To: Mr. Tim Johnson, American TCB
From: David Waitt, Airespace
Subject: Inquiries regarding Certification application for FCC ID QTZVAP1200
Date: 23 Feb 2003

Tim,
Below are the replies to your inquiries regarding this application. The answers are numbered corresponding to your inquiries in your letter dated 10 Feb 2003. If something is unclear, or if you have additional concerns, please contact me.

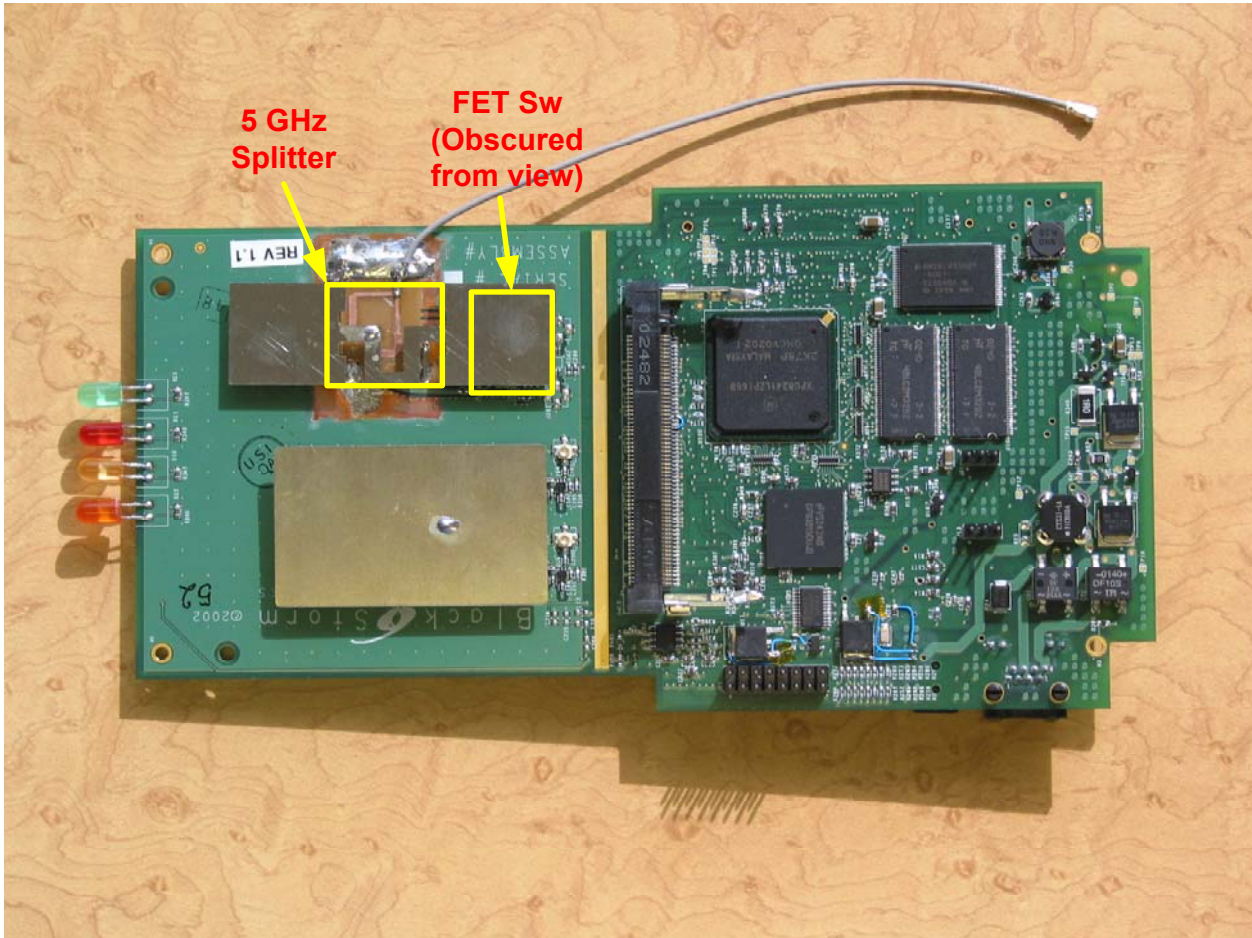
The UNII Block Diagram in the UNII test report shows a splitter that goes to 2 different internal antennas as well as FET switch. The photographs do not appear to show a splitter or switch. Are these in the device. Please explain or provide labeled photographs to show these components.

The photo below shows the 802.11 A side of the product. The splitter is partially obscured the 5GHz antennas, but is highlighted. The FET switch is a small surface mount semiconductor that is completely is beneath the 5GHz antenna and is obscured from view.

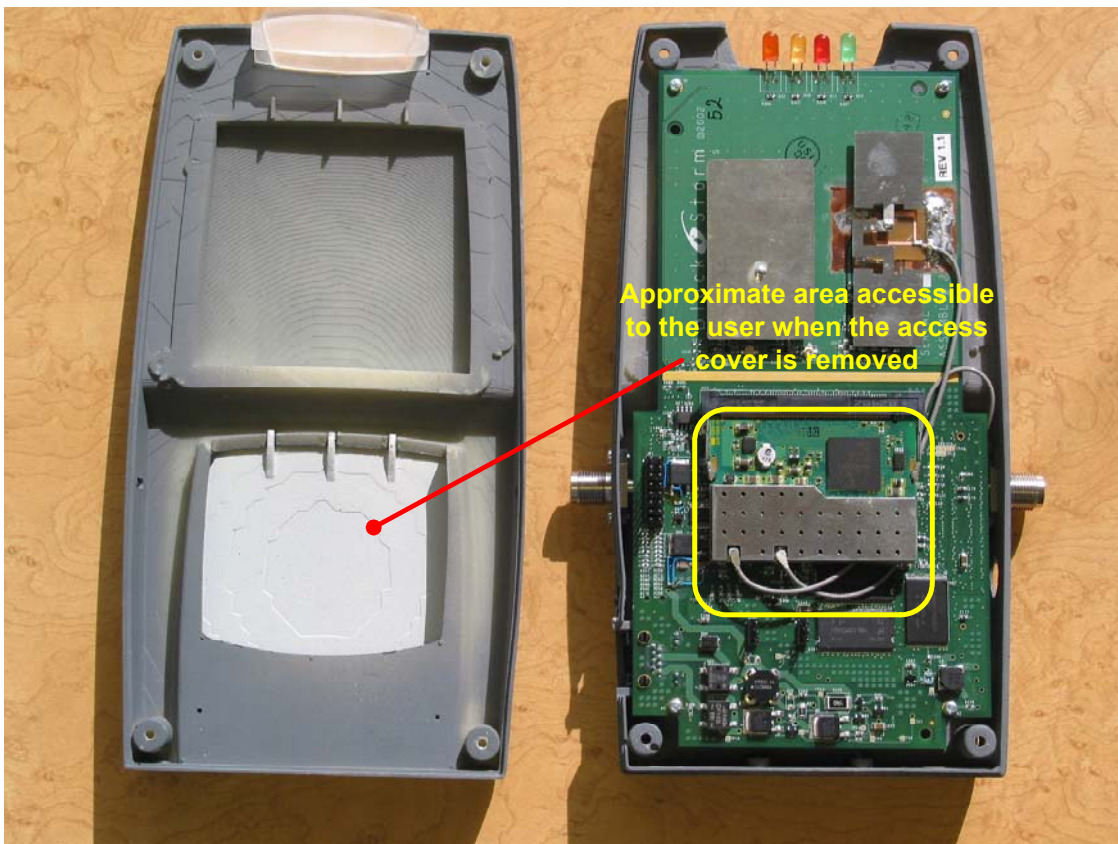
Please provide information regarding 15.407(c), (d), (e), & (g). Note that the "access door" and any information to the user on how to install the unit will be a concern for operation in the 5.15-5.25 due to the integral antenna requirement. Note that an antenna that attaches with a connector inside of the case is acceptable, provided that there is no need for the user to ever open the case.

The photo below illustrates the area that would be accessible to the user of the access panel were removed. The user could install the card and connect the coaxial cables to the module. There is no need for the user to open the housing of the VAP1200 in order to perform an upgrade to the product. Note that at this time, an upgrade to the product is not possible. The current VAP1200 includes both 802.11 A & B cards, thus there is no upgrade path possible. Upgrades will only be possible when single band units are made available. These single band VAP radios will be certified separately and the compliance mechanisms for allowing an upgrade will be addressed at that time. (See attestation letter and additional letter addressing 15.407 (c) (d) (e) (g))
